#### **ORDINANCE AMENDMENT REVIEW SHEET**

C20-2022-015 - Consider an ordinance amending City Code Title 25 to amend the North Burnet/Gateway Regulating Plan to modify the Gateway and Midway Zones, within the Transit Oriented Development Subdistrict, to increase the maximum floor-to-area ratio and building height when using a development bonus.

## Figure 4-3 : Maximum Floor - to - Area- Ratio (FAR) with Development Bonus

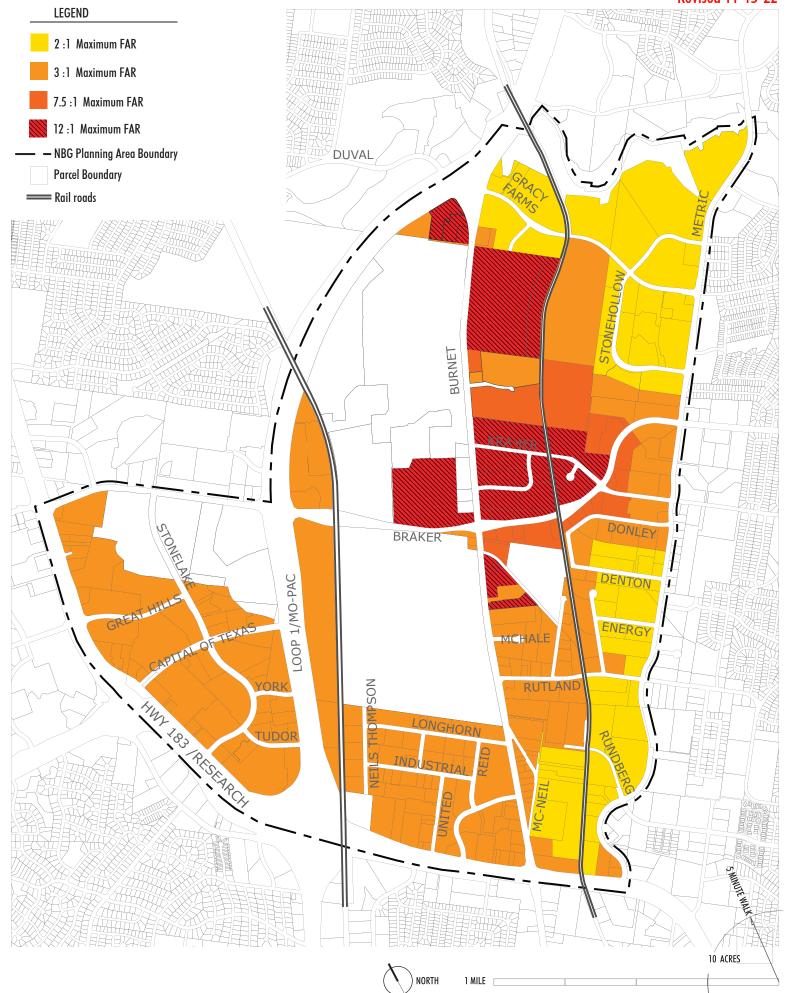
TOD-Gateway Zone and TOD-Midway Zone will increase the maximum FAR and building height when using a development bonus as follows:

- 1. For the TOD-Gateway Zone, modify the maximum FAR from 8:1 to 12:1.
- 2. For the TOD-Gateway Zone, modify the maximum building height from 360 feet to 491 feet.
- 3. For the TOD-Midway Zone, modify the maximum FAR from 5:1 to 7.5:1.
- 4. For the TOD-Midway Zone, modify the maximum building height from 240 feet to 327 feet.
- 5. Revise Figure 4-3: Maximum FAR with Development Bonus, of the North Burnet/Gateway Regulating Plan as described above. (See Attachment "A").
- 6. Revise Figure 4-5: Maximum Height with Development Bonus, of the North Burnet/Gateway Regulating Plan as described above. (See Attachment "B").
